M5 Junction 10 Improvements Scheme

7.5 Transport Assessment Appendix I – WCHAR

GG 142 WCHAR Preliminary Design
Review Report

Figure 3-1: Possible conflict points for cyclists

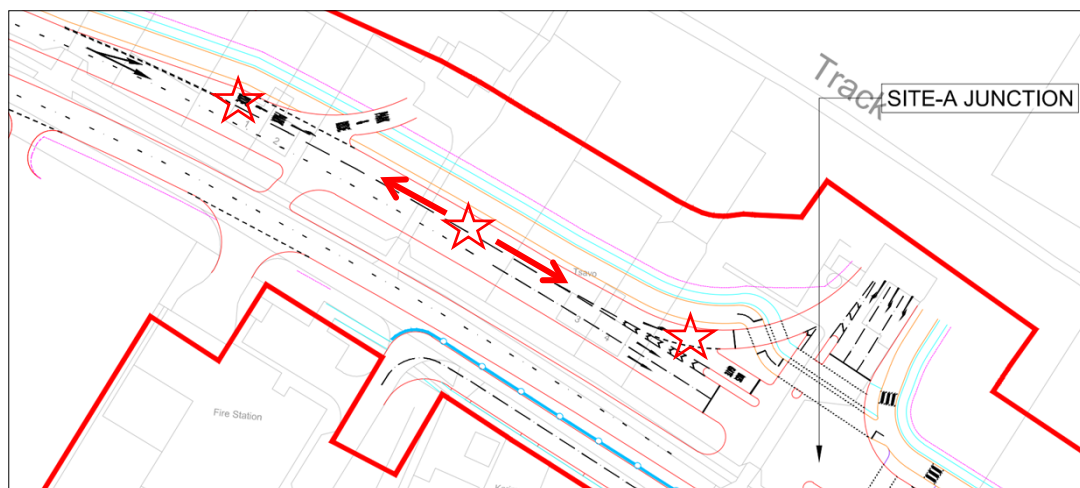
- 3.21.8 Inbound on-road cyclists could be at risk of being struck by left-turning vehicles, either at the park and ride site entrance or where vehicles would be turning left at Site A, Site B and Gallagher Junctions. On the approach to Site A, Site B and Gallagher Junctions the conflict points would be expected to be where vehicles move to the nearside from the ahead lane. This could bring them into conflict with a cyclist already in the nearside/bus lane or at the point where the left turn lane peels away from the ahead lanes but the bus lane commences/recommences. In the latter locations cyclists wishing to proceed ahead could be struck by left-turning vehicles as they move to the nearside. These potential conflict points are highlighted by red stars in Figure 3-1.

Figure 3-2: Movement towards the offside required by cyclists following the bus lane

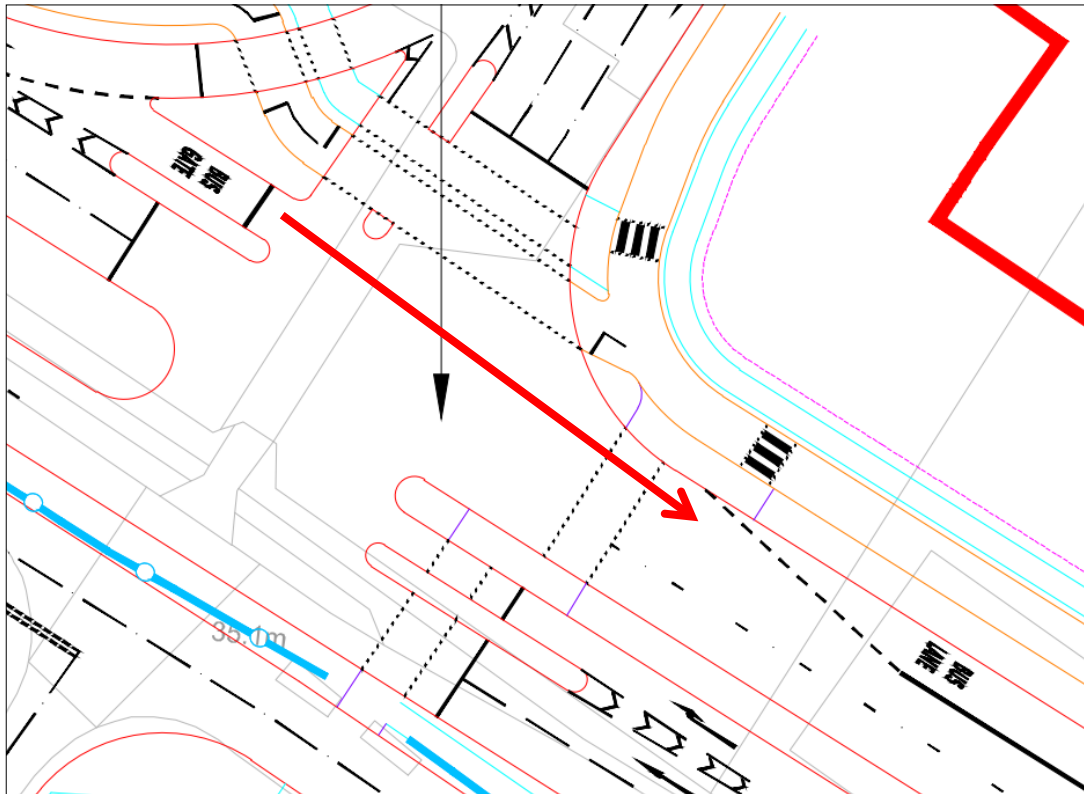
- 3.21.9 At Site A and Site B Junctions, the bus lane downstream of each junction is offset to the right relative to the upstream entry to the junction. This could lead to cyclists in the bus lane being squeezed by buses (or other vehicles in the bus lane) against the kerb as there may seem to be too little room caused by this change of alignment mid-junction. The movement to the offside required by cyclists as they proceed across the junction is shown by the red arrow in Figure 3-2.

- 3.21.15 There is an opportunity to amend the alignment of the nearside eastbound exit kerb at Site A and Site B Junctions. This could be designed such that the change in alignment to the offside is not as sudden and thus reduce the likelihood of a cyclist exiting the junction into the bus lane being squeezed against the kerb by a bus (or other vehicle in the bus lane).

Figure 3-3: Example of where the end of the bus lane and left turn are likely to create conflicts for cyclists (highlighted by the red arrow)

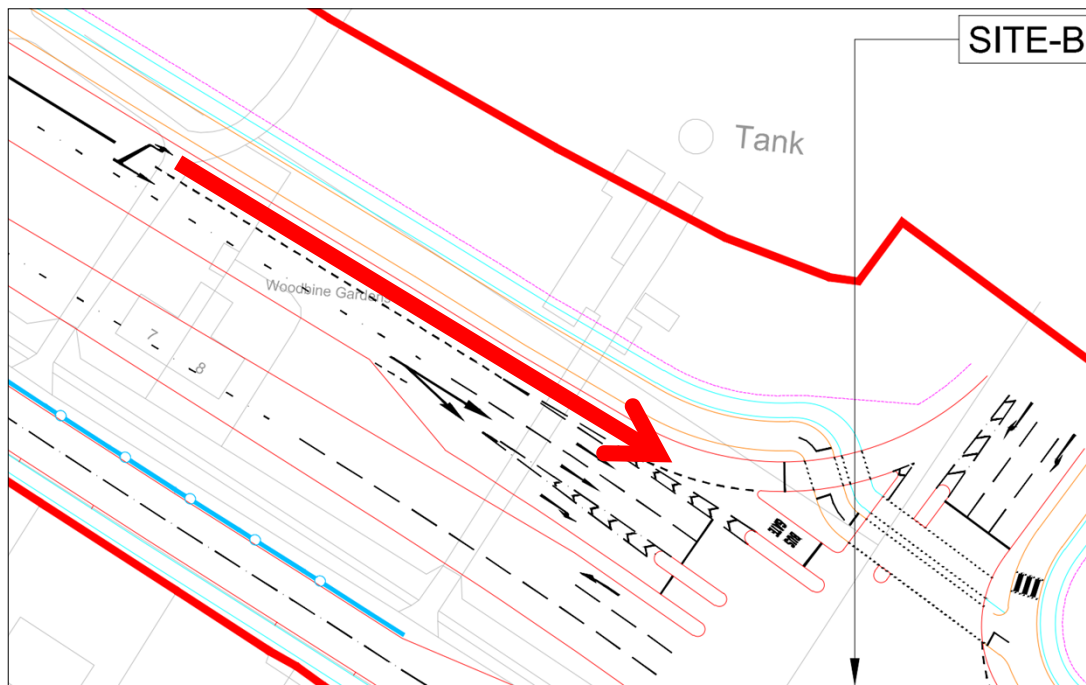
- 3.21.10 At the Site B and Gallagher Junctions, the bus lane terminates and becomes a left-turn lane. This is likely to lead to conflicts between cyclists in the bus lane and left-turning vehicles.
